### Your comment on the Ashbourne project draft conditions

To the Expert Panel, Ashbourne Fast Track Application,

Engineering Drawings for the Northern Solar Farm:

The document in question is called Proposed Subdivision Plan for Lots 8 and 9 C350.

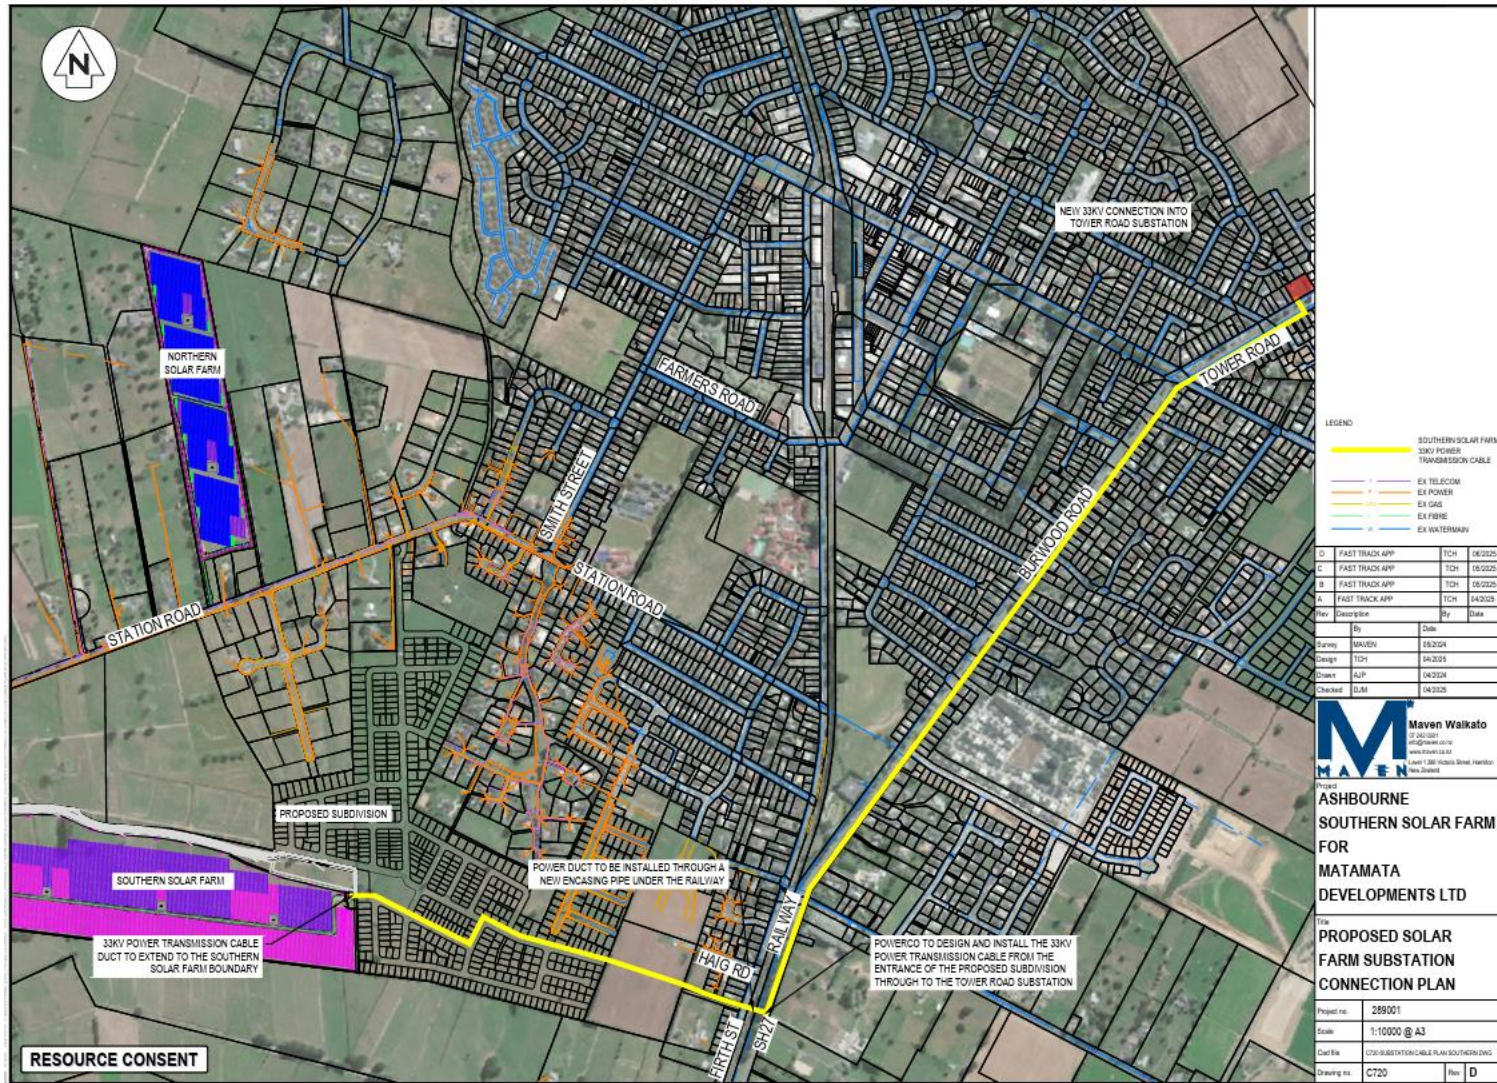
- In Appendix 0 of the Draft Decision– Document list the Northern Solar Farm Proposed subdivision plan for lots 8 and 9 does not have a Rev F.
- Lots 8 & 9 are no longer in the Ashbourne development plan, therefore the document and the table for the Memorandum of Easements, is no longer required.
- I am requesting that this document be removed from the Engineering Drawing for the Northern Solar farm that was uploaded in the correspondence to the Panel on the 13 Feb 2026

Highlighted in Purple line where the Waikato Regional Council Board drain in question runs.

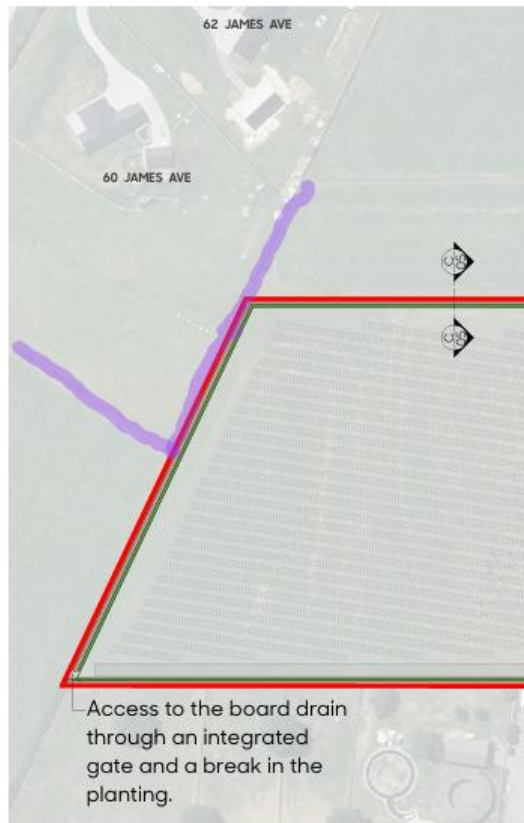
I emailed the panel on 26/11/25, indicating that the gateway and break in the planting are on the North Western corner of the property.

I indicated in my email the path of the drain by highlighting it in purple. See below.

My email stated “This showed that there is still no access to the WRC drain due to the fence and planting.”

“The issue is that the WRC board drain is on the Northeastern side of the northern boundary and in the information from WRC about land drainage from Sept 2024, it states "Under the Waikato regional plan, landowners with drains on their property that are managed by WRC must ensure there is suitable access for maintenance machinery by - Keeping plants or structures more than 10 m away from the drain”

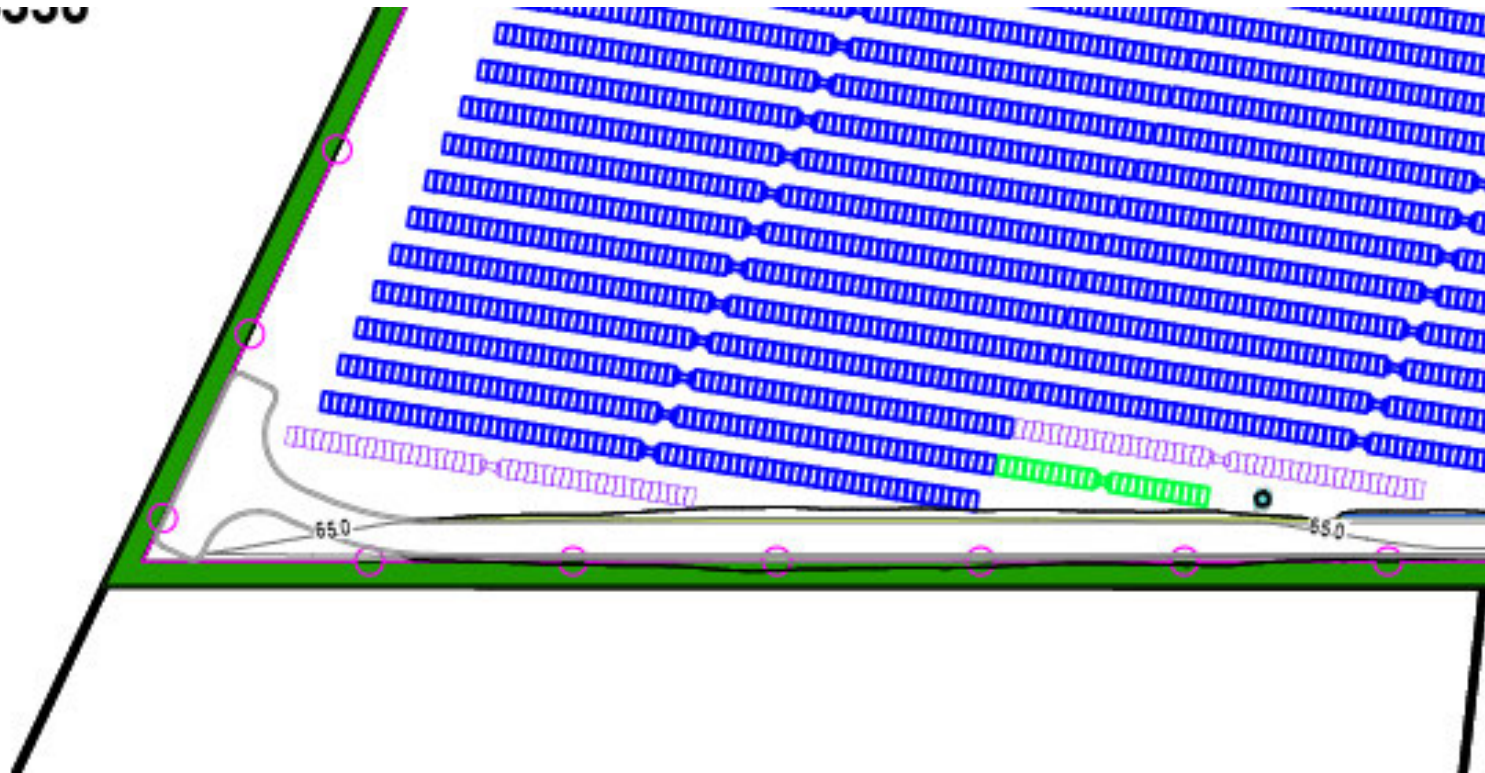
There is no allowance for the 10 m access to the drain that is required by the Waikato regional council, the plan clearly shows the boundary, then the planting area that is 3 m wide (depicted in Green) and they have planned for a 2.2 m high fence. The drain is prone to flooding and requires regular inspection and work to clean/clear it.

From the information provided to the Expert Panel by the applicant, they are allowing a single integrated gateway through the fenceline, but no room for a digger or cleaning equipment to access a drain that is already prone to flooding.”

The planting is right to the boundary and against the drain, as indicated on pg 11 of the document Proposed Contours Plan Sheet 1 of 3 C210-1 Rev E.

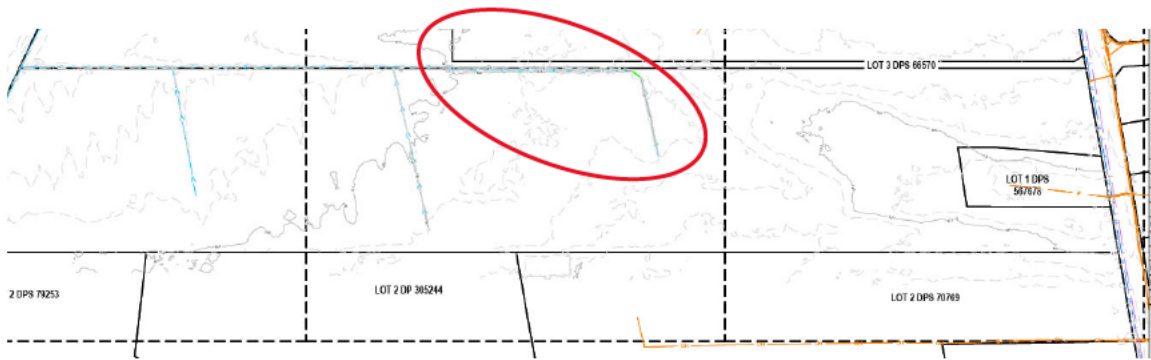
There is no access at all to the drain for cleaning as requested by WRC.

Further to that WRC states "Under the Waikato regional plan, landowners with drains on their property that are managed by WRC must ensure there is suitable access for maintenance machinery by - Keeping plants or structures more than 10 m away from the drain.

Here it can be clearly seen that there is no 10m accessway for the drain, which I noted in my email is prone to flooding.

This needs to be rectified as agreed previously and in line with WRC rule 4.2.18.1

- That the Northern Solar farm northern boundary has the appropriate access designed and approved by WRC to comply with WRC rule 4.2.18.1, including keeping plants and structures more than 10 metres away from the drain (meaning the buffer planting and security fencing)

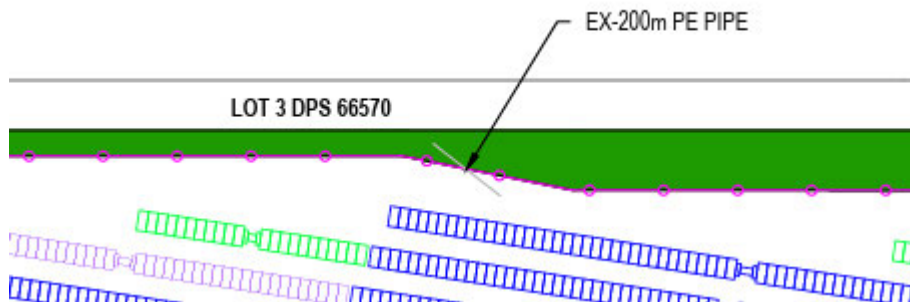
On page 12 of 44 the drain is covered by 3m of buffer planting and the 2.2 m high security fence (see below) which indicates that the drain will be inside the buffer planting zone before the drain goes across the fence to Lot 3 DPS 66570.

Good farming practice requires drain maintenance, and there is, once again, no maintenance access to the drain located on the Northern Solar Farm.

- That all farm drains that pass over the boundary of the Northern Solar farm have accessibility from the Solar Farm to clean and maintain the drains.

(Page 40 of 44 in the document Ashbourne Northern Solar Farm for Matamata Developments Ltd – Proposed Services Key Plan C700 Rev E)

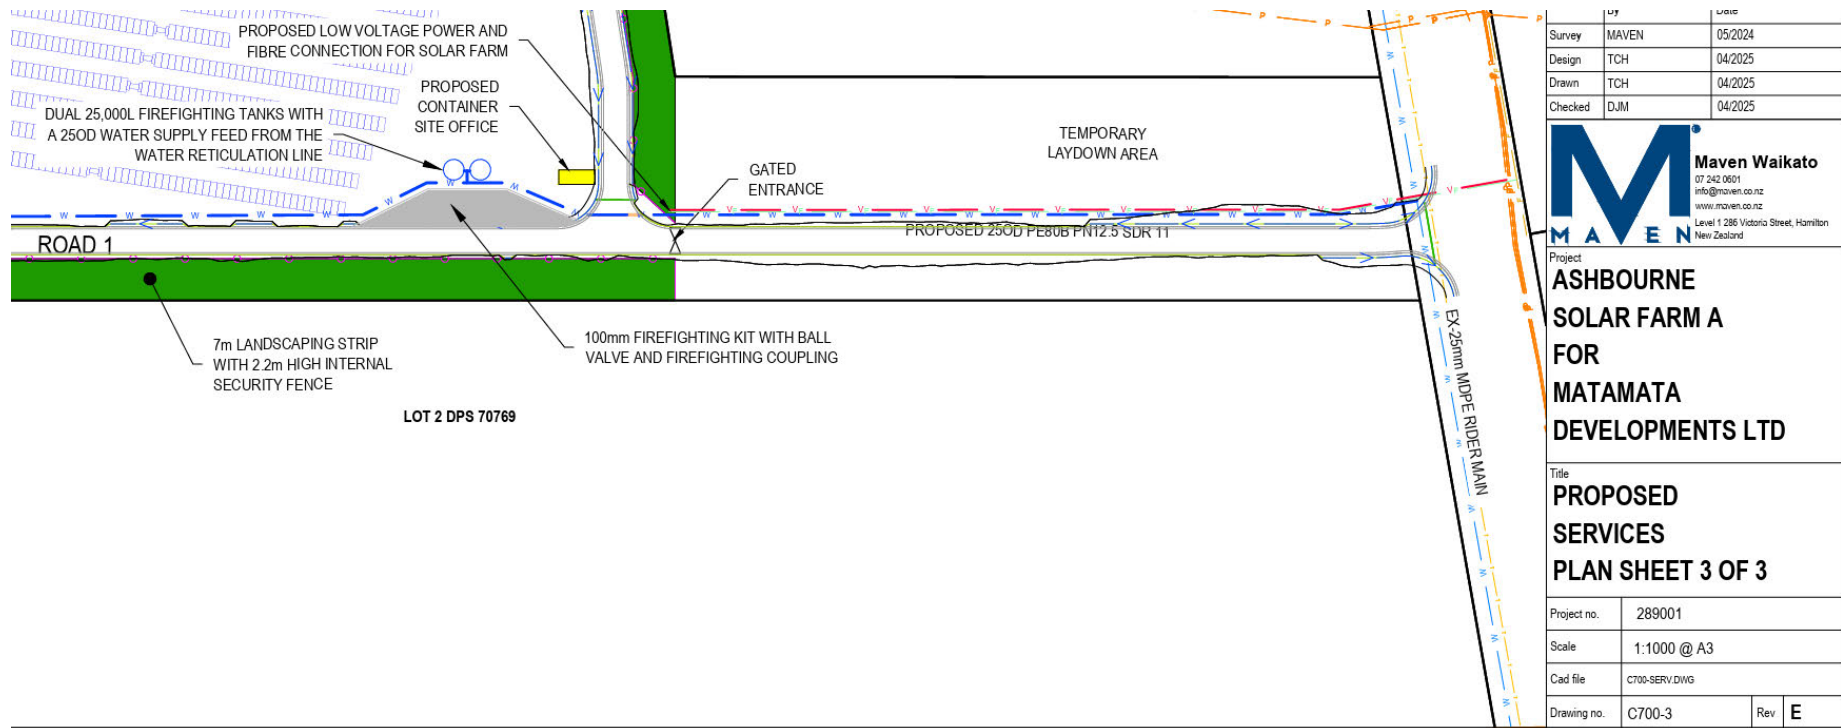
On the latest Engineering Drawings for the Northern Solar Farm, there is an indication that a town water connection will be installed for the firefighting water supply and for the troughs for the animals that will be grazed on the solar farm.

And evidence that the Applicant is still proposing to connect to the town water supply for water for animals is on Ashoubrne Solar Farm A for Matamata Developments Ltd – Proposed Services Plan Sheet 3 of 3 C700-3 Rev E

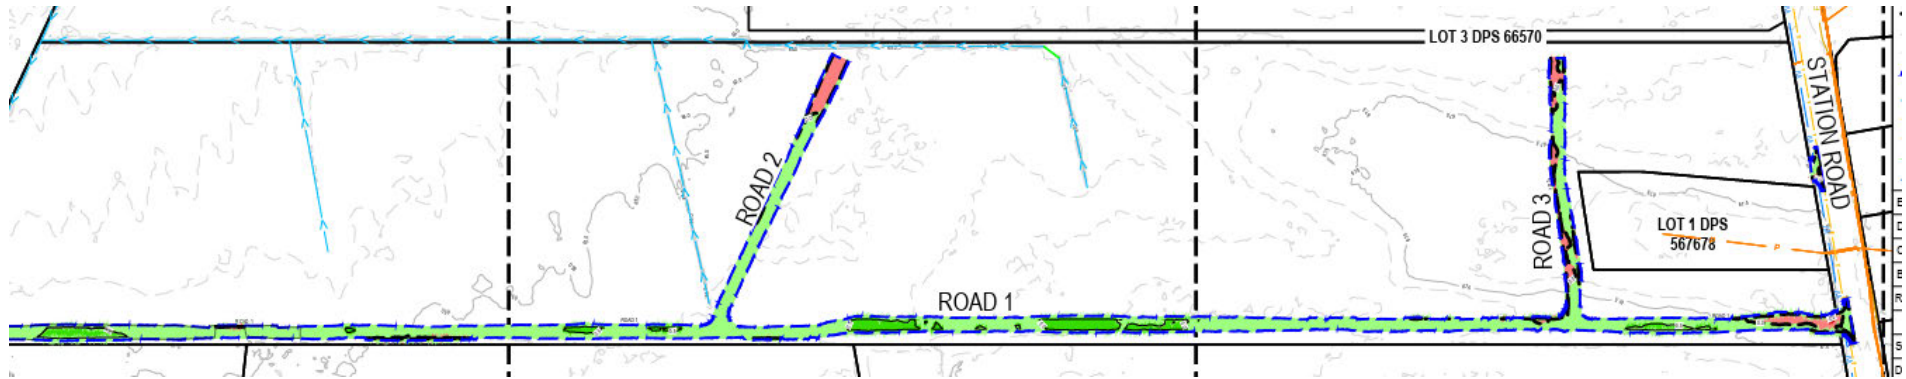
The applicant proposes to connect to the EX-25mm MDPE Rider Main using a Proposed 250D PE80B PN12.5 SDR 11 pipe/hose.

MPDC has set a precedent: existing users of that town's water supply were previously denied a connection for watering animals; therefore, this proposed connection should not be accepted by MPDC. The applicants did mention stock water from the main farm supply being the existing water supply to the Northern Solar Farm Block.

- That the consent holder does not get water for the northern solar farm from the existing 25mm MDPE Rider main for the watering of animals and filling the firefighting tanks, as there is an existing main farm supply already to the Northern Solar Farm block.

On page 14 of the document, Ashbourne Northern Solar Farm for Matamata Developments Ltd – Proposed Cut/Fill Key Plan C220 Rev E, there is an area of proposed cut where the driveways for the proposed, then cancelled, Lots 8 and 9 were located.

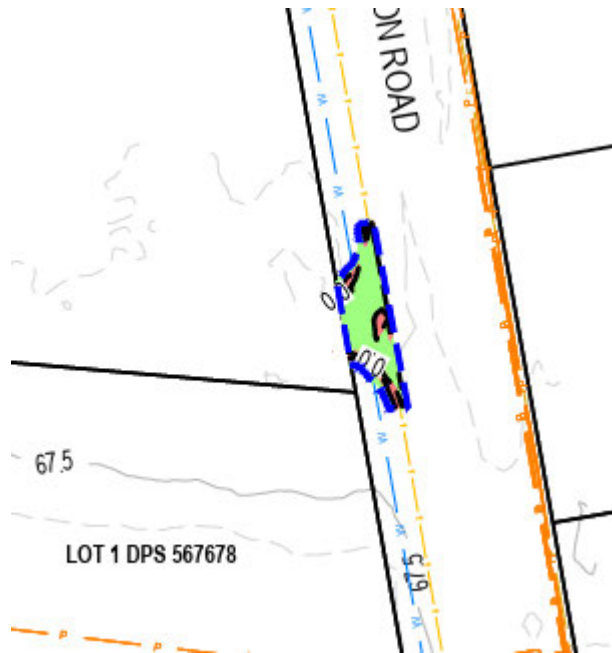
Why is there a need to have this detailed on the Plan for cut and fill if the subdivision of lots 8 & 9 is not going to occur?

This needs to be removed from the cut-and-fill plan. The property is permitted 1 entrance way for vehicle access. I have attempted to call MPDC to clarify if a property of that width would be permitted a second driveway, but I assume that all the engineers are furiously gathering information for the Council's reply to the draft decision as well.

Looking at the plan, it seems that road three on the northern solar farm has been located too close to the boundary of 172 Station Road to allow access to the land that was going to be Lot 8 & 9 and was recently removed from the project. There is no break in the fencing or planting to allow access into that paddock. To my mind, it is an easy fix to move the solar farm road 3, fencing, and planting 5 m to the north to allow adequate access for vehicles/tractors for animal grazing. Then there would be no need for the extra driveway, and the land can be used as suggested by the applicant.

- That no additional entrance way is permitted on the Northern Solar Farm land as the applicant can reconfigure the internal roading and buffer planting to allow access to the grazing area (formerly Lot 8 & 9).
